Application Number: PL/25/1281

Location: ST LAWRENCE HOUSE, ABBEY SQUARE, READING

Proposal: Application for Approval of Details Reserved by Condition 7 (Odour Assessment) of application PL/23/1091

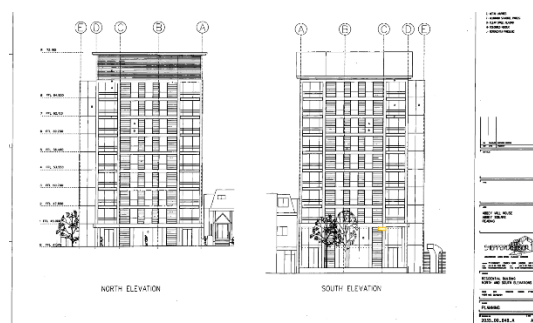
“The location of the louvre was determined through a review of the available servicing options and the site characteristics and constraints. Whilst the original building construction included an external square clad enclosure attached to the side of the building (see photo attached), it is neither sized nor constructed to meet the requirements to accommodate extraction requirements. The enclosure is too small and is unable to comply with the required current regulations to accommodate compliant ducting as well as the associated equipment to enable its operation and vertical extraction over this distance. The enclosure terminates at 8th floor level of the residential apartments, providing an outlet between the two windows at this floor. The proximity of the enclosure to the residential windows which it runs up against identified potential concerns in respect of impact on these properties, whilst its size does not provide any opportunity

to insulate the ducting and equipment that would be required to be housed in this enclosure to enable effective operation of the extract. It is not possible to enlarge the enclosure as it is sandwiched between two sets of residential windows on both sides. As a result alternatives were required to be explored and delivered.

The location of the kitchen extraction has been selected through further assessment of the feasible locations for the extraction, technical regulation compliance and position in respect of the other accommodation within the building and adjacent properties locations. The extraction is required to be installed within either the north or south elevations of the building due to the construction, orientation and position in respect of neighbouring buildings which limits the potential to locate within either the east or west façade. The proximity of the Blade and Abbey Baptist Church buildings to the east and west do not facilitate the potential for extraction to either of these elevations.

The existing building includes residential windows and balconies to both north and south elevations and the proposed location positions the extract to the far end of the southern building elevation to minimise potential impact on residential properties on the upper floors. The extract location has been positioned to avoid being located directly below an existing window, with the area to the above residential dwellings mainly forming a solid cladded panel. The extract is located set back from the residential frontage above by a significant overhang, with the extract set down and back from the floors above. The position of the extract louvre is shown in yellow on the below image and elevation drawing.

...The location is positioned so as not to sit directly below openable windows of the residential units above and designed and configured to minimise potential impact.
